Access Compliance Report Public Rights-of-Way (Curb Ramps)

Main Street: REATA_RD Cross Street: N/A Location: NE

ADA ID: RPRK211118133741 Ramp Type: Type 1 - Perpendicular Initial Pass/Fail: Fail Overall Compliance: No Severity Score: 2

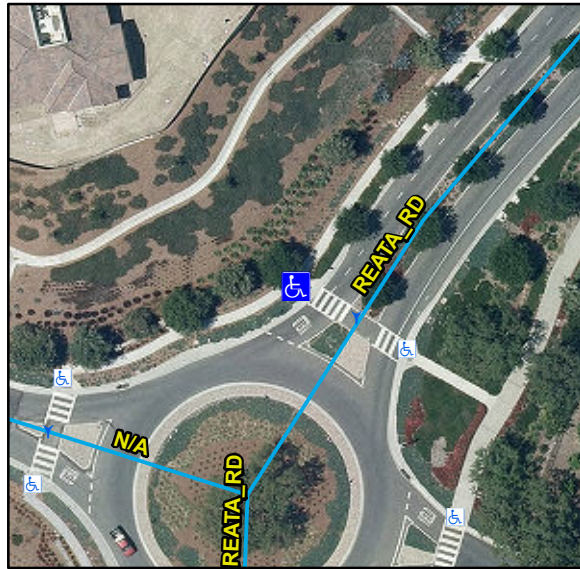
R304.2.2, R304.5.3, STD 1115

Compliance	Description	Data	Compliance	Description	Data
N/A	Ramp Length (in)	61	N/A	Flare Type LT	
Yes	Ramp Width (in)	60			N/A
Yes	Ramp Run Slope (%)	6.7	N/A	Flare Slope LT (%)	N/A
No	Ramp Cross Slope (%)	2.7	N/A	Flare Traversable LT	N/A
N/A	Landing Present	N/A	N/A	Flare Type RT	
N/A	Landing Length (in)	N/A			N/A
N/A	Landing Width (in)	N/A	N/A	Flare Slope RT (%)	N/A
N/A	Landing Run Slope (%)	N/A	N/A	Flare Traversable RT	N/A
N/A	Landing Cross Slope (%)	N/A	N/A	DWS Provided	N/A
N/A	Landing Movement Obstructed?	N/A	N/A	DWS Contrast	N/A
	Landing Movement Type	N/A	N/A	DWS Length (in)	N/A
N/A	Landing Shared	N/A	N/A	DWS Full Width	N/A
N/A	Clear Space	N/A	N/A	DWS Offset Left (in)	N/A
N/A	Clear Space To Crosswalk (in)	N/A	N/A	DWS Offset Right (in)	N/A
N/A	Marked Crosswalk 1	Yes	N/A	Marked Crosswalk 2	N/A
	Crossing 1 Direction	SE		Crossing 2 Direction	N/A
	Marked Crosswalk 1 Width (in)	144		Marked Crosswalk 2 Width (in)	N/A

N/A	Ramp Inside Crosswalk 1	Yes	Yes	Ramp Inside Crosswalk 2	N/A
	Crossing 1 Slope (%)	5.1		Crossing 2 Slope (%)	N/A
	Crossing 1 Cross Slope (%)	2.2		Crossing 2 Cross Slope (%)	N/A
N/A	Gutter Ponding	N/A	No	Curb Slope	5.4
Yes	Gutter Lip Height (in)	0		Road Run Slope (%)	N/A
N/A	Gutter Run Slope (%)	N/A		Road Cross Slope (%)	N/A
N/A	Gutter Cross Slope (%)	N/A			
Yes	Overall Surface Condition: Acceptable		Yes	Perp Joint Present	Yes
	Cross Gutter Present?	No		Spandrel Present?	No
	Replace Cross Gutter?	N/A		Replace Spandrel?	N/A

Remove & Replace Entire Ramp.
